Delphi Medical CLA

International Components Corporation Fabricators International Limited Manufacturing Subsidiary	
Title	Delphi medical CLA Output :19V@6.7A
Date:	07-13-2007
Sheet	1 of 1
Revision	B6
Drawn By:	AXH
Checked By:	XJ
Approved By:	KW

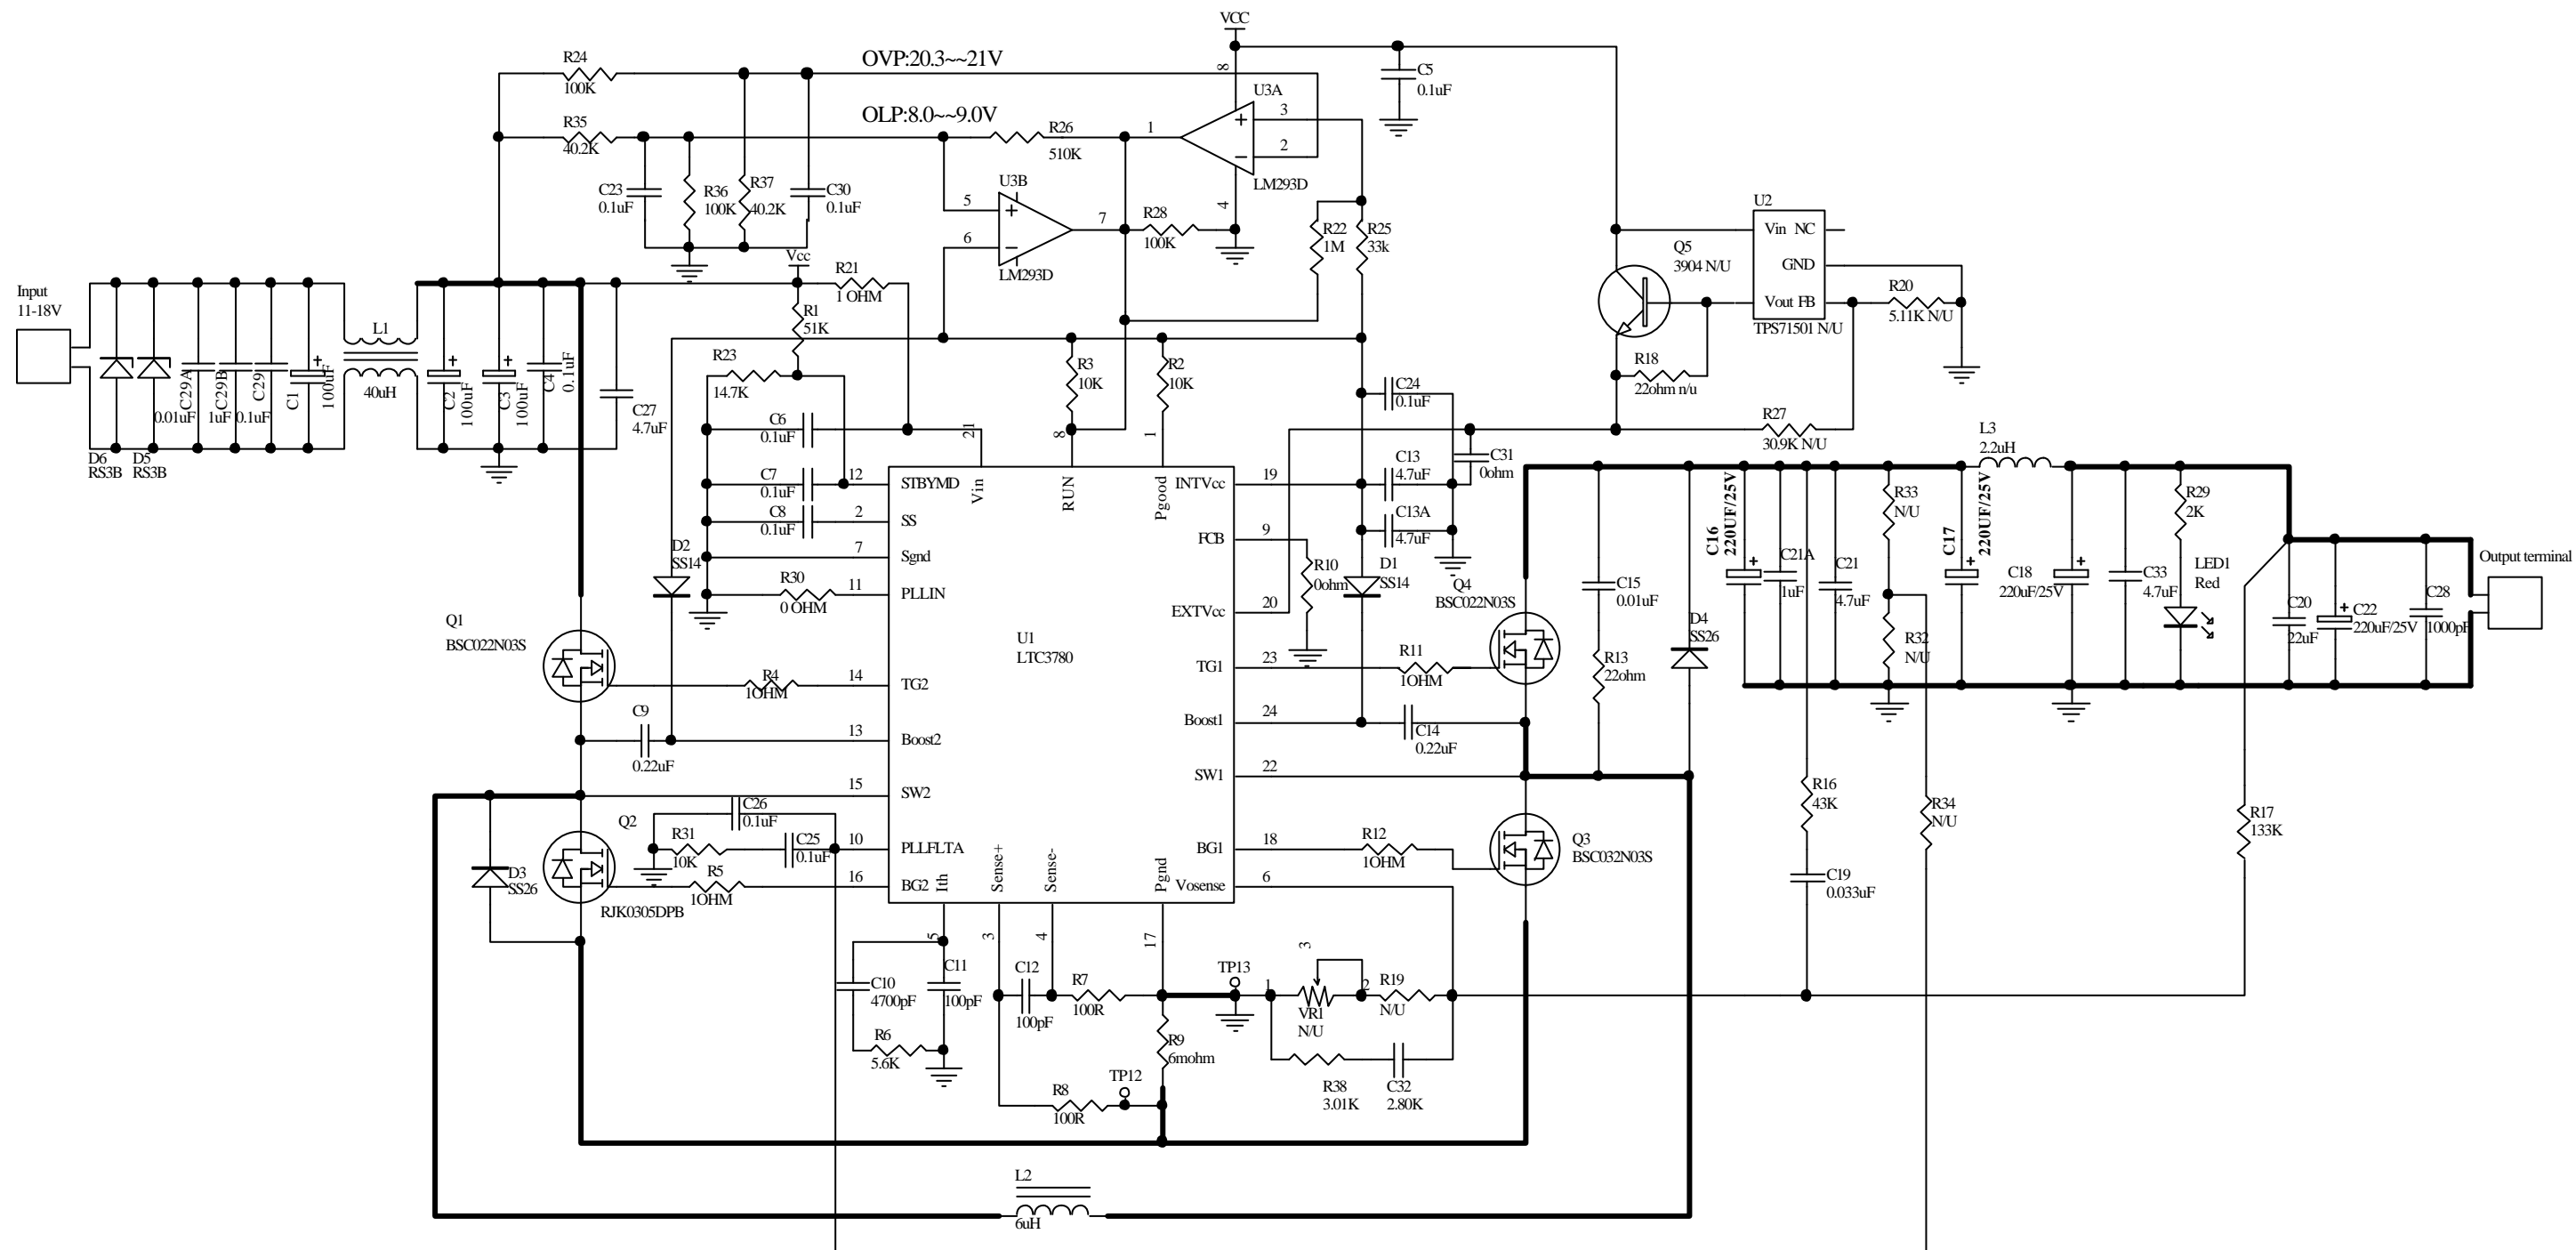
B5 TO B6 add C29A C29B C21A
R38 N/U change to 3.01K 1%
C32 N/U change to 2.8K 1%
VR1 R19 change to N/U
Q3 change to BSC032N03S
